ADDENDUM NO. 06

Jay County Solid Waste Management District New Recycling Facility

Addendum Date: April 23, 2026

III. DRAWING DETAIL: TYPICAL EXTERIOR CONCRETE SECTION

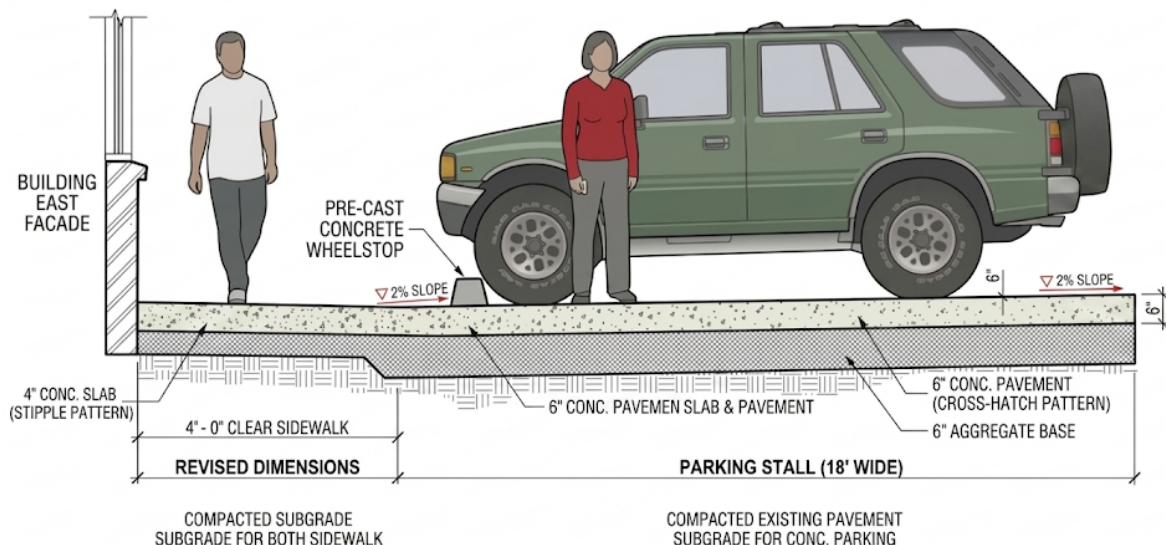
Q1: What are the construction requirements for the concrete parking and sidewalk on the east side of the building?

A1: The parking stalls located adjacent to the sidewalk on the east side shall be concrete with wheel stops to separate parking from sidewalk. All topsoil must be removed per the **GME Geotechnical Report (G26-013296)**. Construction shall follow the detail provided below.

CONSTRUCTION KEY NOTES:

1. **SIDEWALK:** 3,000 PSI concrete per **Division 03**. Reinforced with 6x6-W2.9xW2.9 WWF.
2. **PARKING SLAB:** 6" thick 3,000 PSI concrete. Reinforced with 6x6-W2.9xW2.9 WWF
3. **SUBBASE:** 4" minimum compacted #53 Crushed Stone.
4. **PRE-CAST CONCRETE WHEELSTOP:** 6' Length. 6" Height. 8" Width. Anchored with (3) 1/2" dia. X 14" Long Galvanized Steel Dowels.
5. **SUBGRADE:** Remove all organics per **GME Report G26-013296**. Proof-roll per **Section 31 20 00**.
6. **JOINTS:** Expansion joints (1/2") at building interface and 50' O.C. Control joints at 5' O.C. for sidewalk and 10' O.C. for parking.
